Technical Bulletin

TB5000-012

5000 Bodymaker

ROLLER BEARING TYPE CAM FOLLOWERS

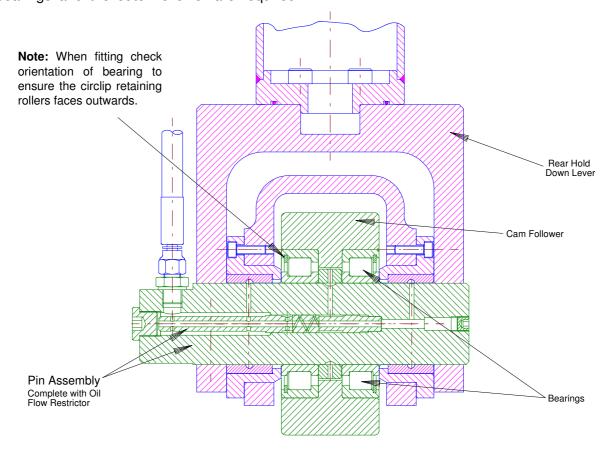
SUMMARY: CarnaudMetalbox Engineering have introduced a new design of cam follower as standard on the 5000 Bodymaker, this incorporates roller bearings as opposed to a bronze bush in the previous arrangement.

This cam follower arrangement has an improved life expectancy and will combat faster acceleration rates required for high speeds because of the smaller contact area given by the rolling elements.

When initially retrofitting the cam follower it will come complete with bearings, spindle and oil flow restrictor spiral but once fitted only the bearings and the outer follower are required for spares. This technical bulletin is applicable to all 5000 Bodymakers, and was fitted as standard from serial number 112S, available in the simple to fit form retrofit package. This enables a total fitting time of four hours.
